EL CAR WASH NOVI II JSP24-25

Consideration of El Car Wash Novi II for Preliminary Site Plan approval. The subject property is 0.54 acres in size, is zoned TC Town Center District, and is located on the east side of Novi Road, north of Grand River. The applicant is proposing to reutilize the existing car wash building for a new car wash.

REVIEW	RESULT	DATE	COMMENTS
Planning	Approval Recommended	01/17/25	ZBA variances: <ul style="list-style-type: none"> • Parallel parking space within the required 20' parking setback on north side • Lack of separate 18-foot bypass lane • Shortage of vehicle stacking spaces prior to the tunnel <p>Items to be addressed at Final Site Plan submittal</p>
Engineering	Approval Recommended	11/26/24	Items to be addressed at Final Site Plan submittal
Landscape	Approval Recommended	01/02/25	Planning Commission waivers (all supported by staff): <ul style="list-style-type: none"> • Insufficient greenbelt area • Insufficient parking lot interior trees • Insufficient parking lot accessway perimeter trees • Insufficient foundation landscaping area and coverage provided • Lack of loading zone screening <p>Items to be addressed at Final Site Plan submittal</p>
Traff

DEMOLITION PLAN

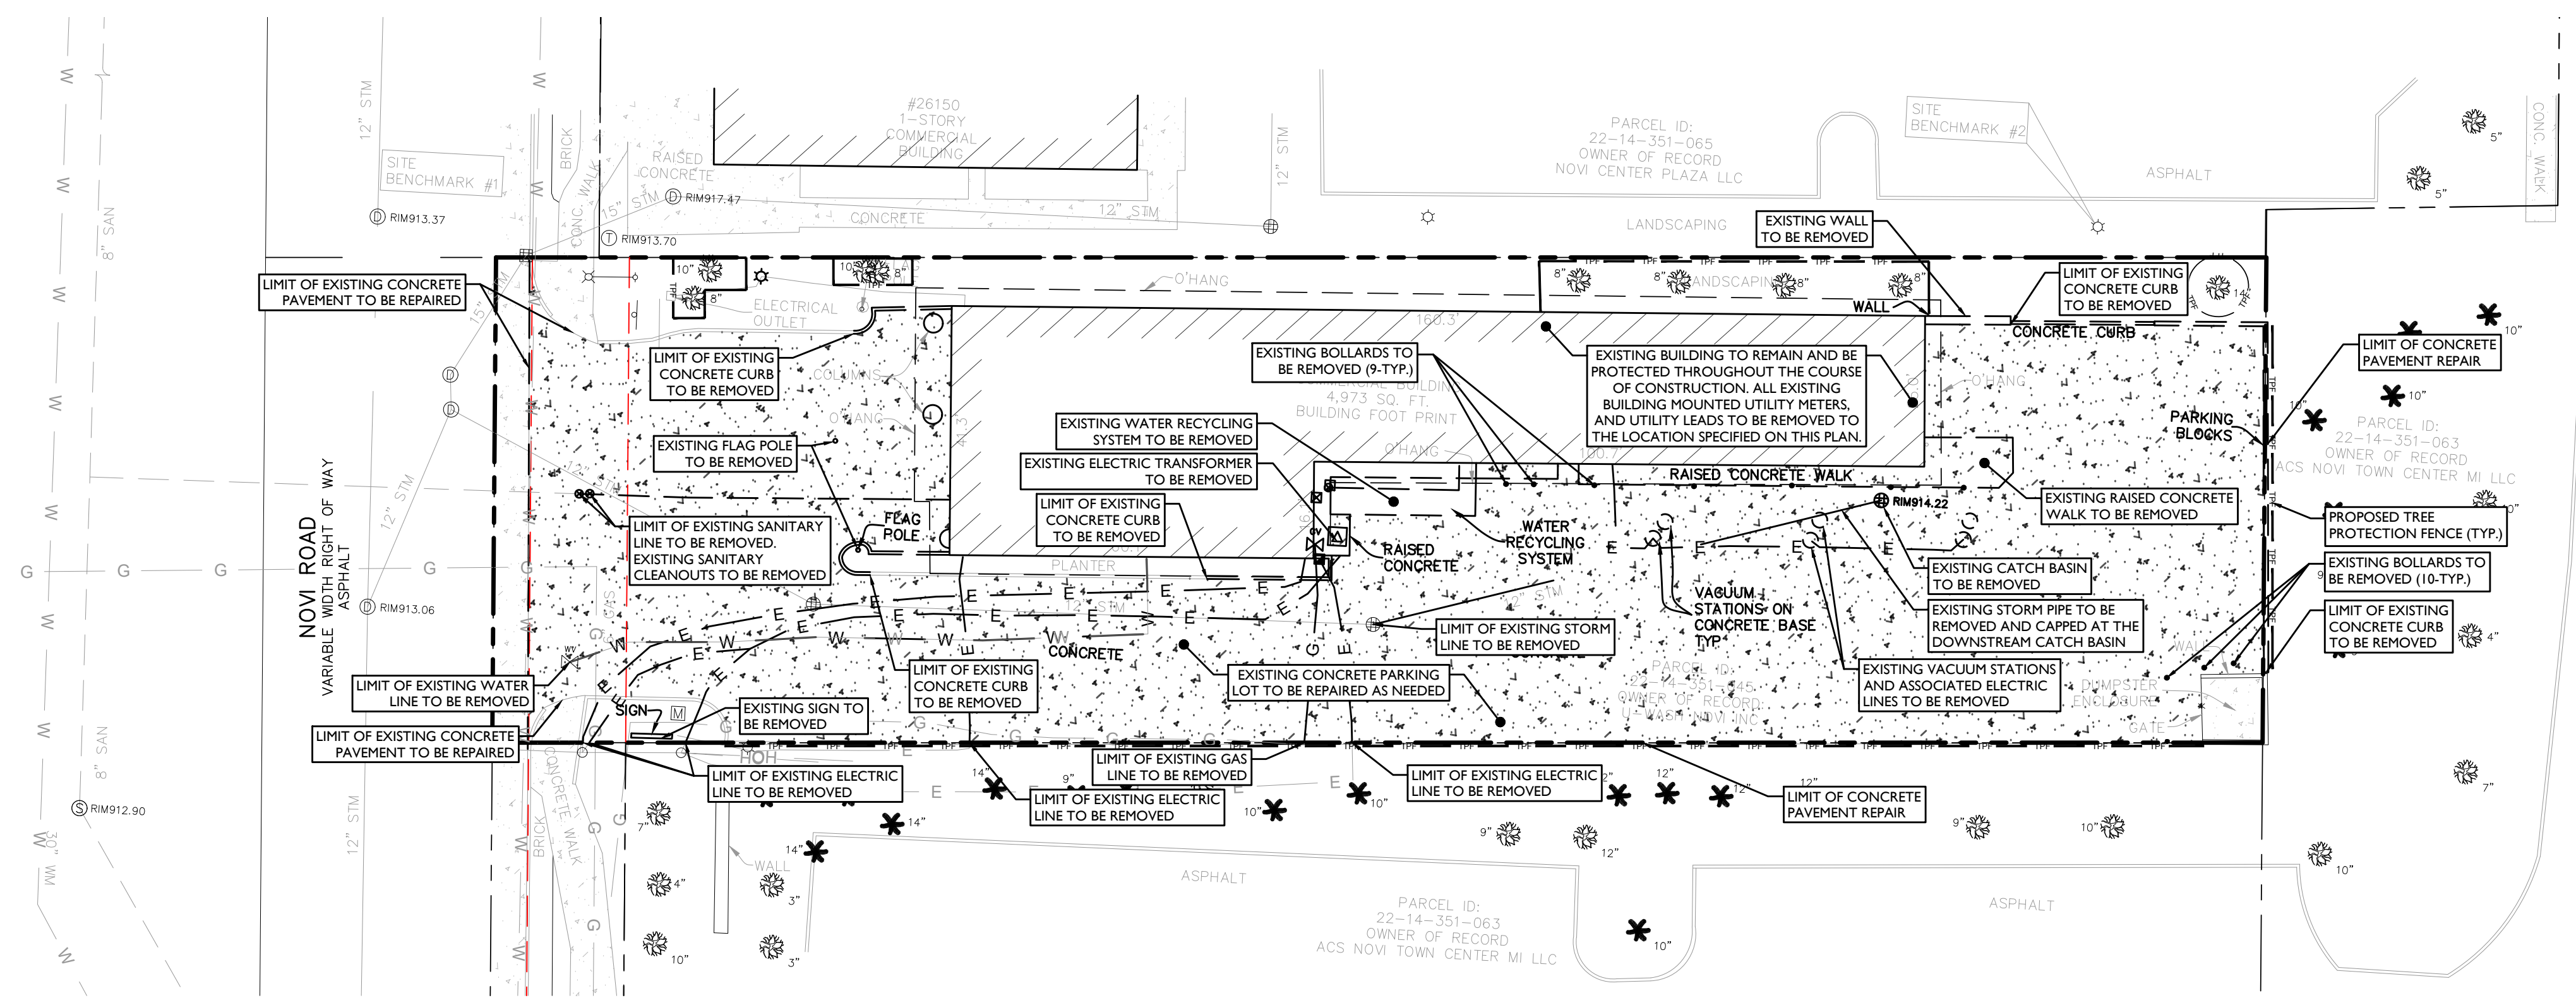
- Sheet C-2 Demo Plan notes five existing wall mounted lights on the north side of the building to be removed – this conflicts with existing fixtures to remain note on Sheet C-7. Please clarify.

1. Please copy the tree protection fence detail from Sheet C-9 to Sheet C-2.
2. Please show the existing tree at the northeast corner of the building being protected by tree protection fencing from the construction east of it.

Callout to remove existing lights along the north side of the building has been removed. See sheet C-2 of the revised Site Improvement Plans

Tree protection added for tree at northeast corner of the building, see sheet C-2 of the revised Site Improvement Plans

TITLE:
LIGHTING PLAN

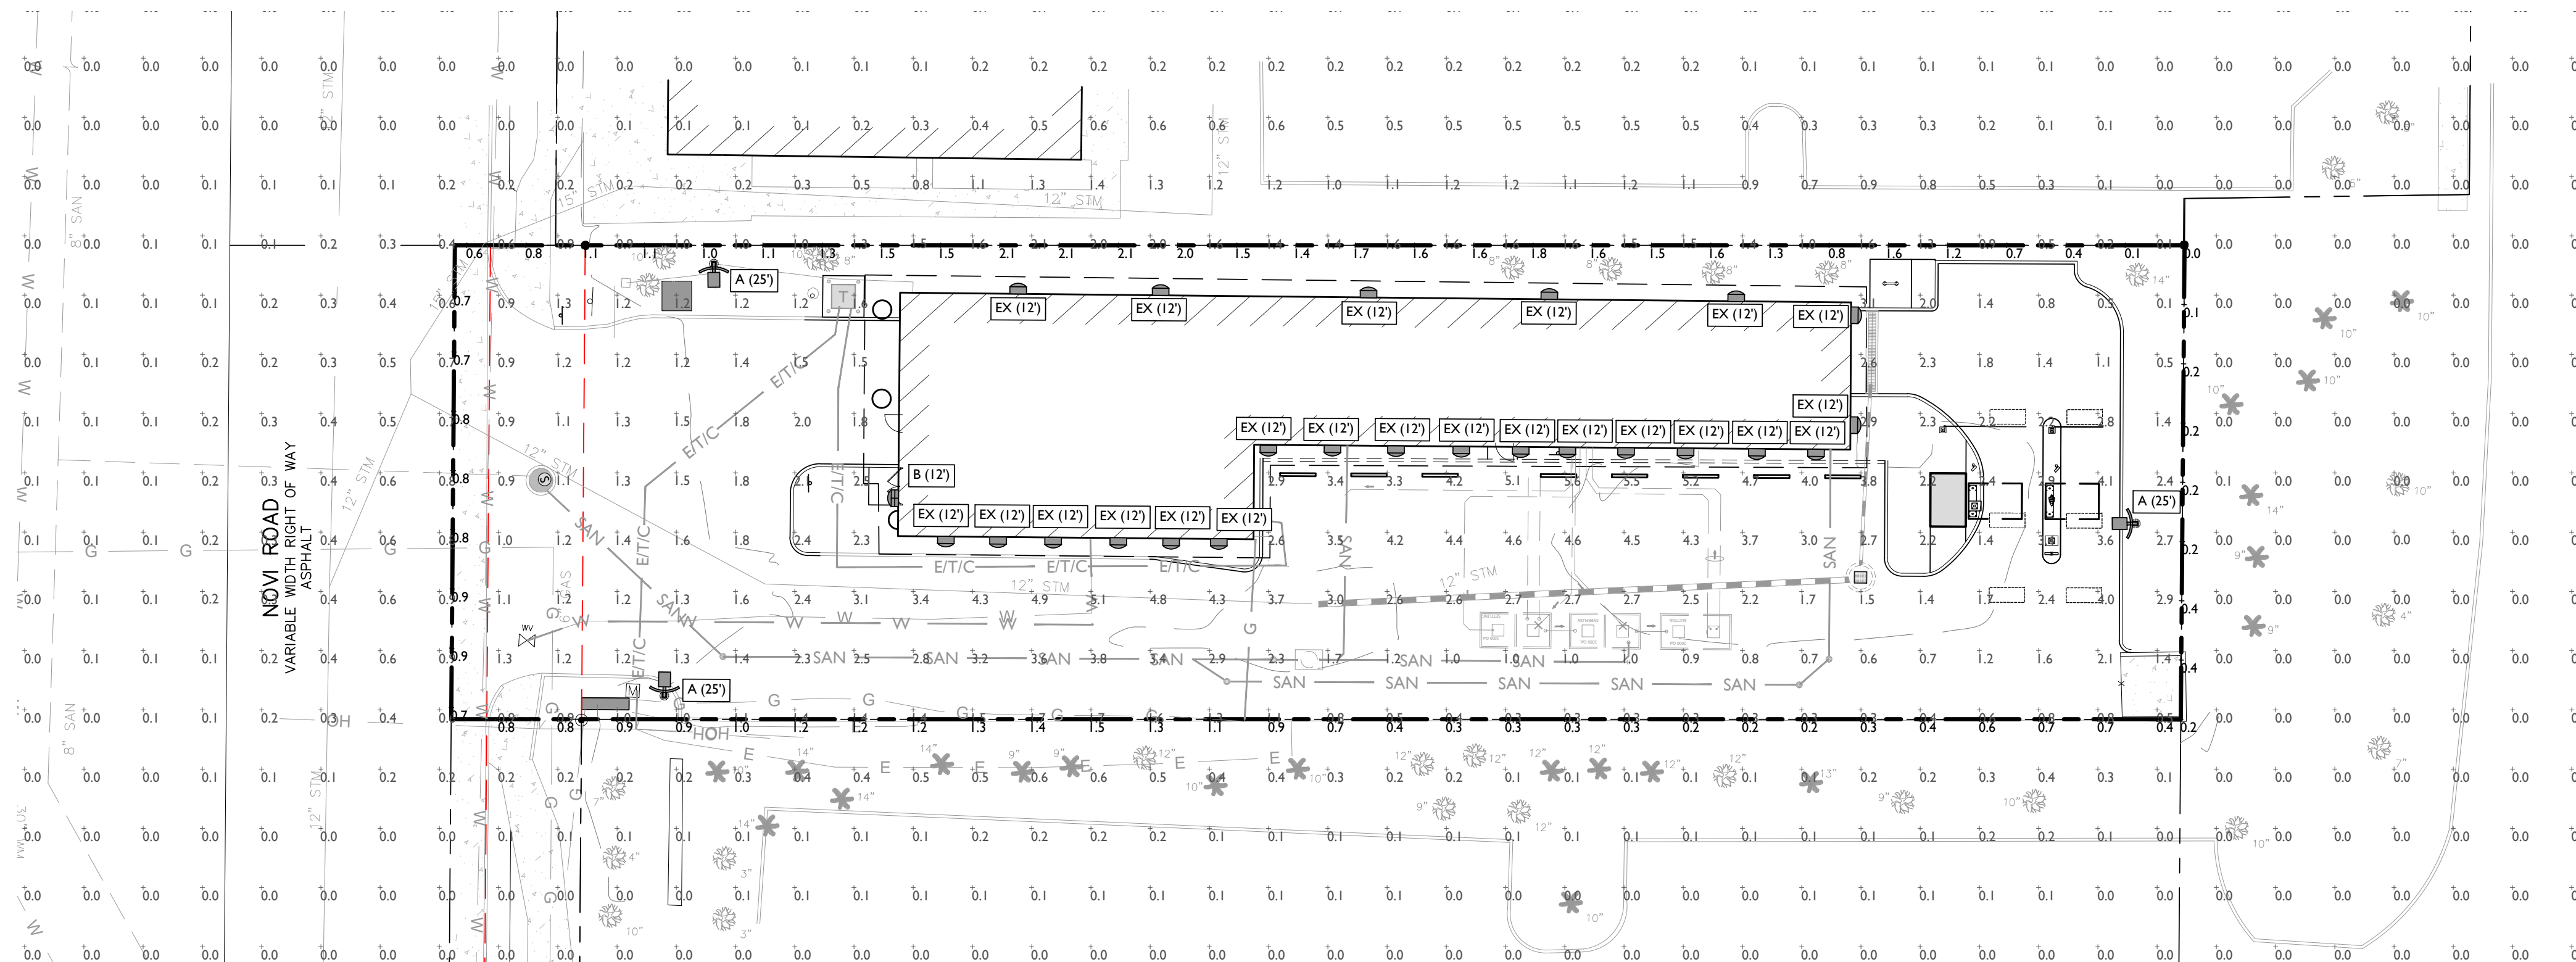
9. Lighting Plan (Section 5.7.2.A.i): Sheet C-2 indicates five existing wall mounted lights on the north side of the building are to be removed. Sheet C-7 indicates existing fixtures are to remain and be protected during construction. Please clarify whether these lights are to be removed or remain.

All existing light fixtures to remain. See sheet C-7 for accurate lighting design within the revised Site Improvement Plans

All existing building fixtures are to remain. See sheet C-2 & C-7 within the revised Site Improvement Plans
